SUNDRY NOTICES AND REPORTS ON WELLS
Do not use this form for proposals to drill or to re-enter an abandoned well. Use Form 3160-3 (APD) for such proposals.

8. Well Name and No.
Hale 11 Federal #1

Hale 11 Federal 1
30-015-25778
Matador Production Company
January 20, 2016
Conditions of Approval

Permanent Abandonment of Production Zone Conditions of Approval

PROPOSED

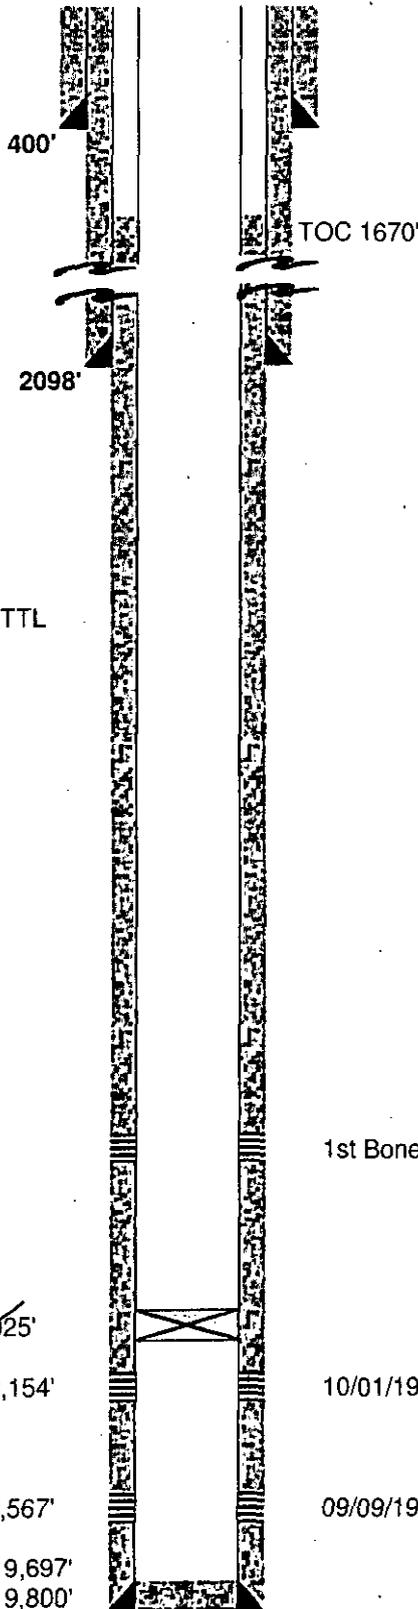
- 1. Operator shall place CIBP at 8,023' (50'-100' above top most perf) and place 25sx of Class H cement on top. WOC and tag.**
- 2. Must conduct a casing integrity test before perforating and fracturing. Submit results to BLM. The CIT is to be performed on the production casing to max treating pressure. Notify BLM if test fails**
